COMMENT FOR CHSRA BUSINESS PLAN:

ADDITIONAL UTILITY RELOCATION COSTS ARE MISSING FROM THE ESTIMATE.

Figure 3.6-5
High-Risk Utilities in the Madera Project Vicinity

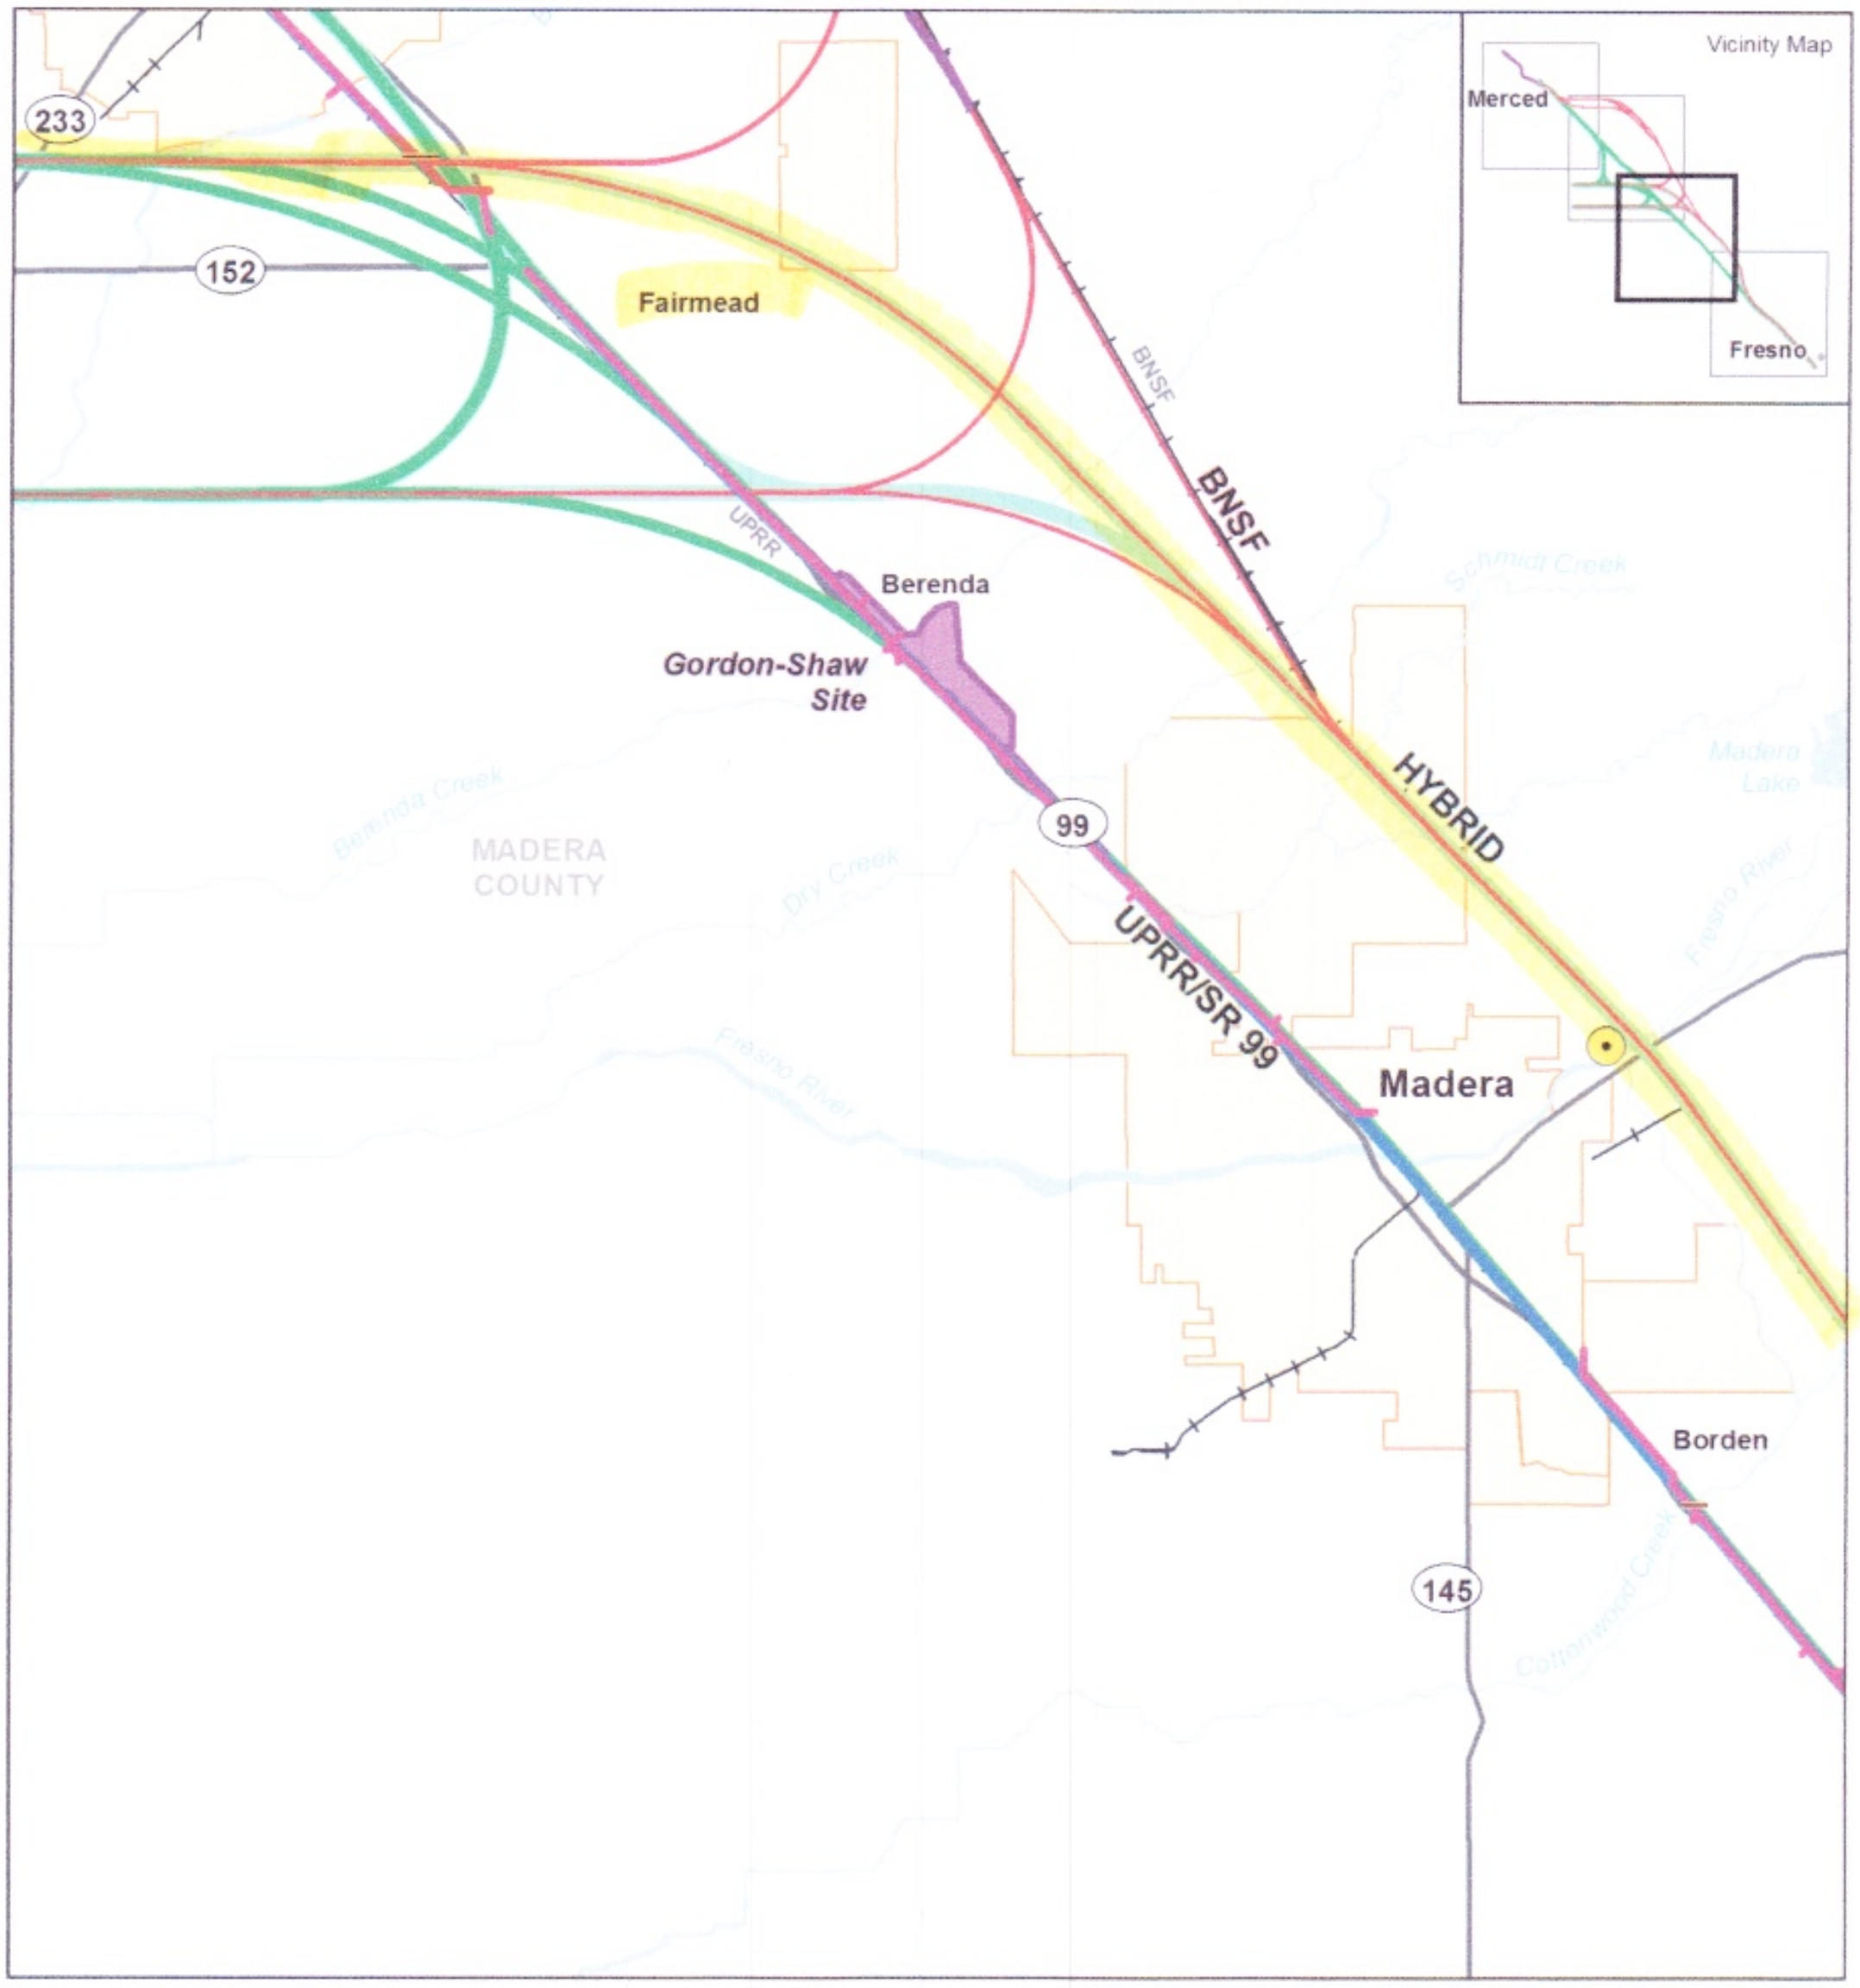
The Authority did not mark this series of high voltage towers on their map of High-Risk Utilities in their Draft Environmental Impact Report (DEIR) or the Final (FEIR). On the EIR maps, there is a notation that the electrical transmission lines will be shown, but this set of HVTs is not shown. See Attachment 6, Public Utilities and Energy.

125kV HIGH VOLTAGE
MISSING
FROM MAP

ATTACHMENT 9
GENERAL ORDER 95
CLEARANCES

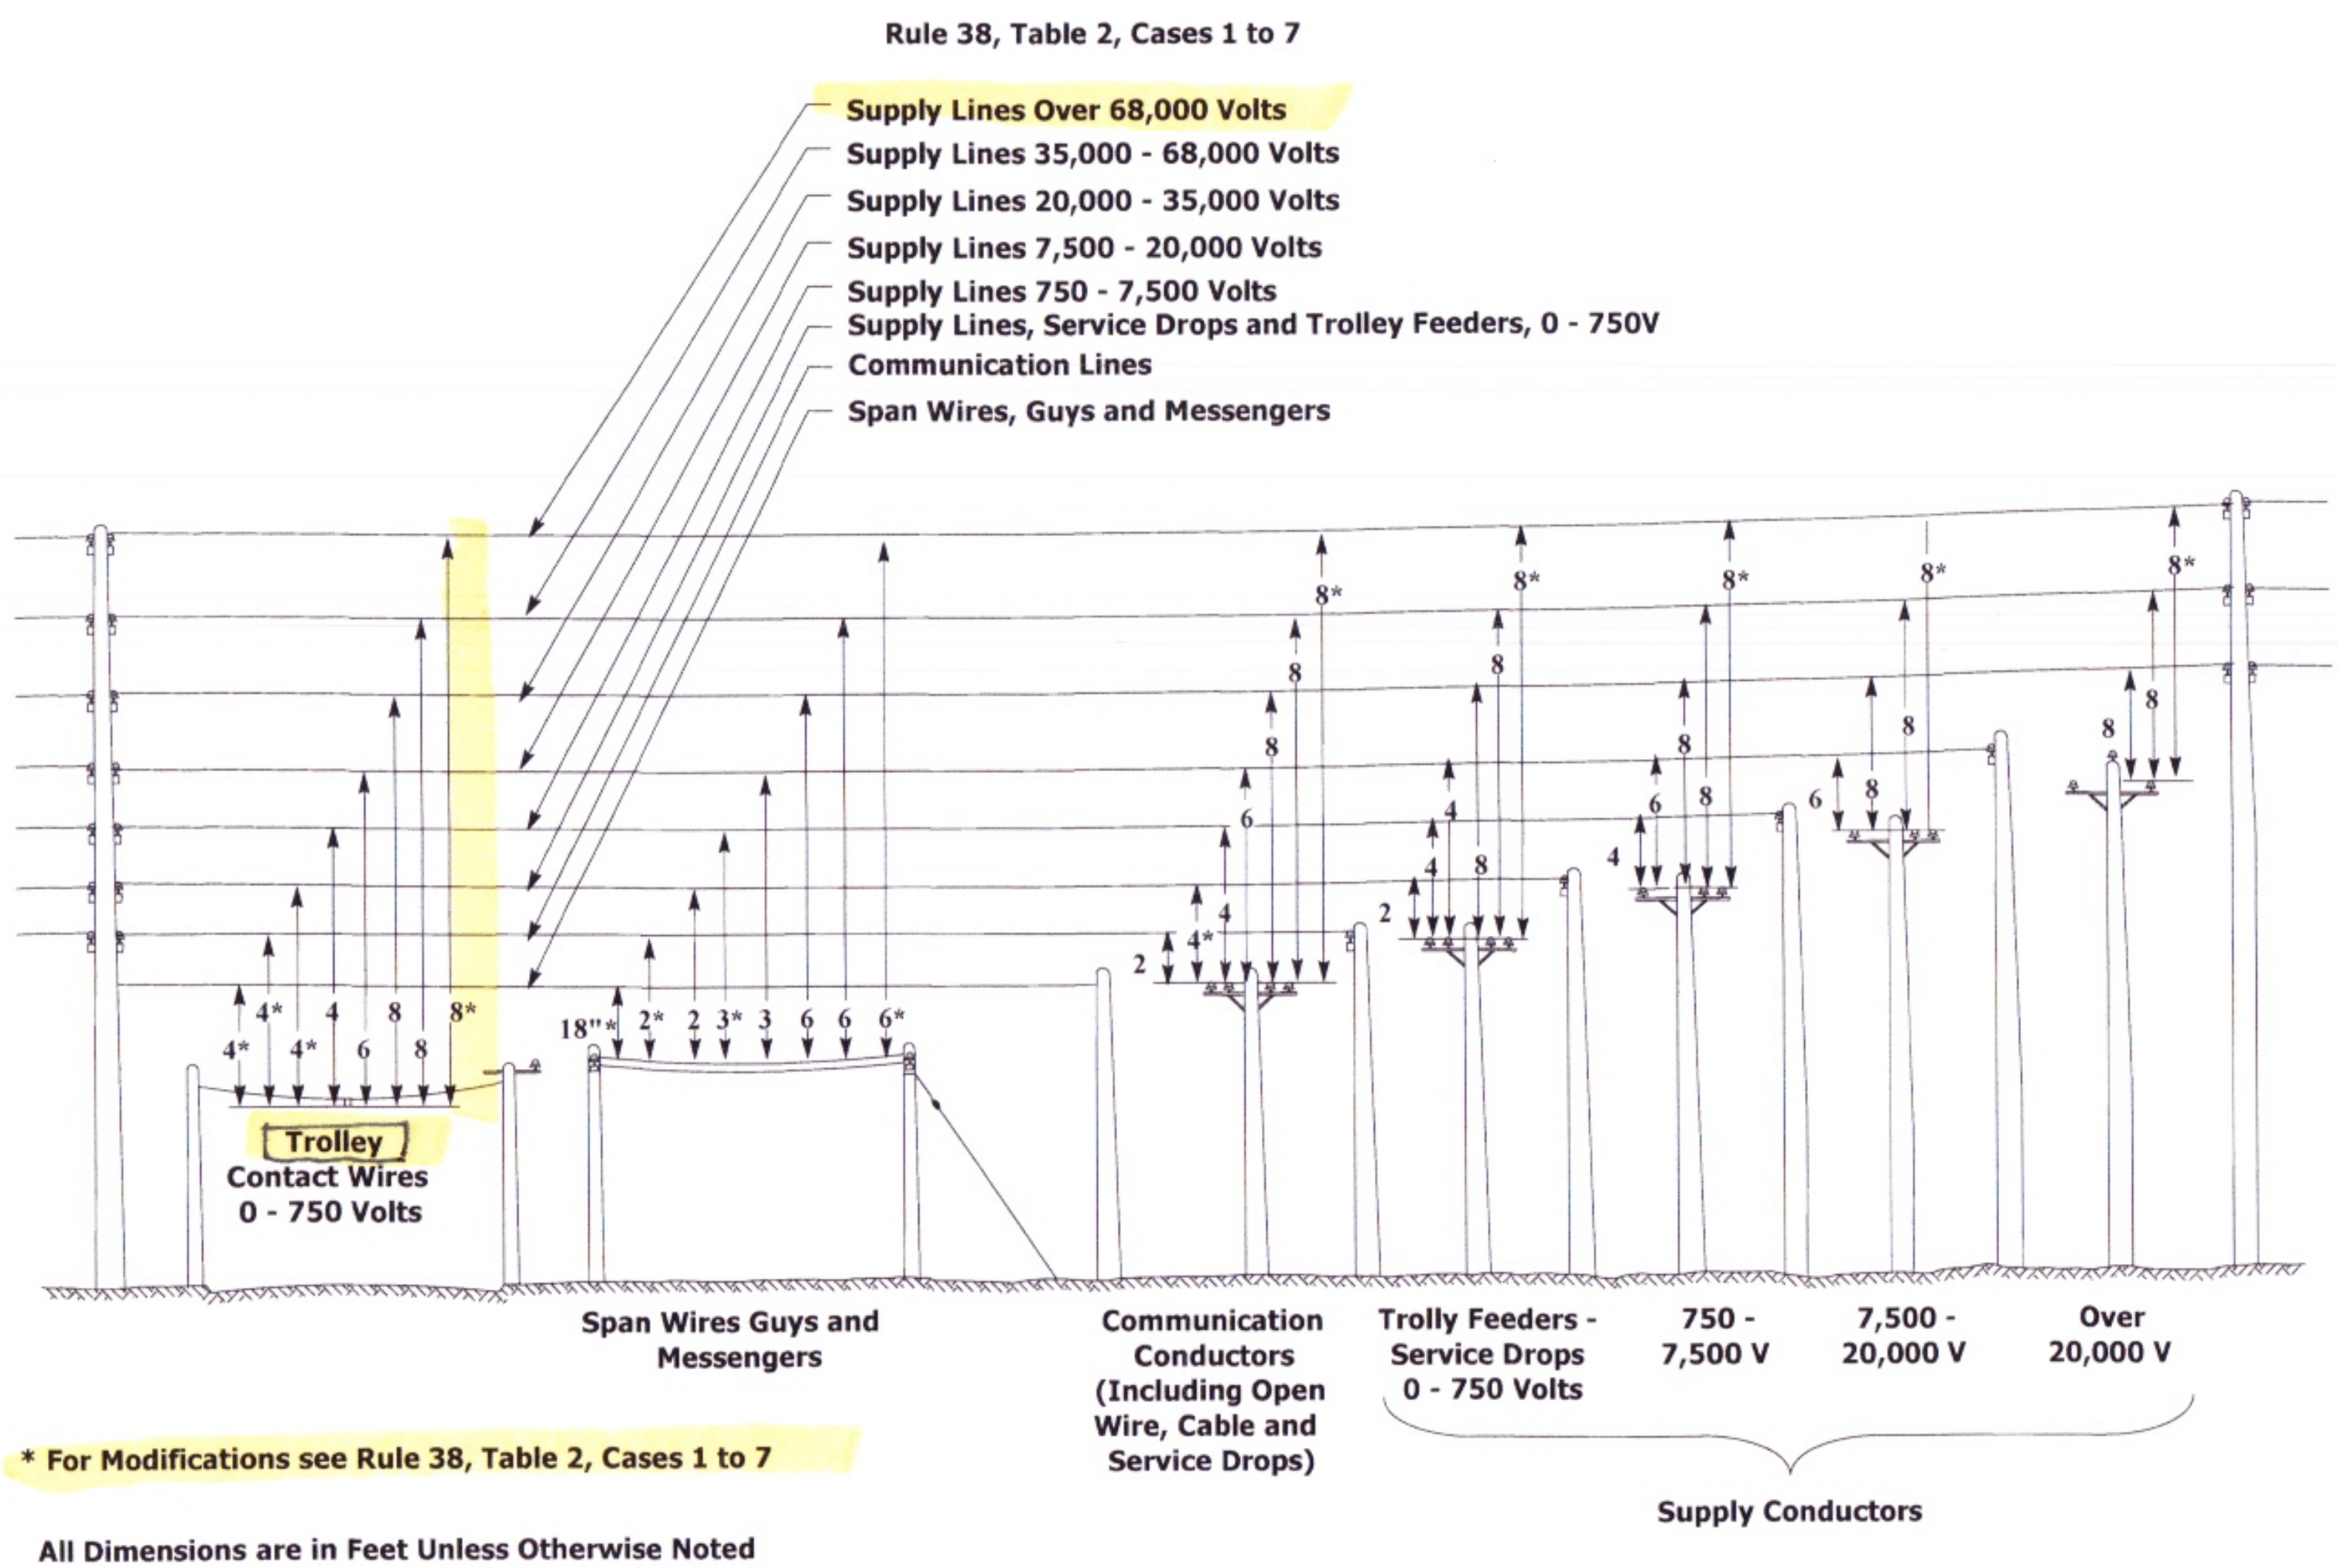
In the State of California, when a set of power lines cross over an electrified railroad track, the rules governing the distance between the two sets of lines are found in the California Public Utilities Commission (CPUC) General Order 95 (GO95). These rules were established during the era of trolley car lines, when trolley cars ran at a maximum of sixty miles an hour. These rules have not been updated for speeds of 220 miles per hour.

See Attachment 9 an 10, General Order 95, clearances for overhead wires above a trolly car OCS.
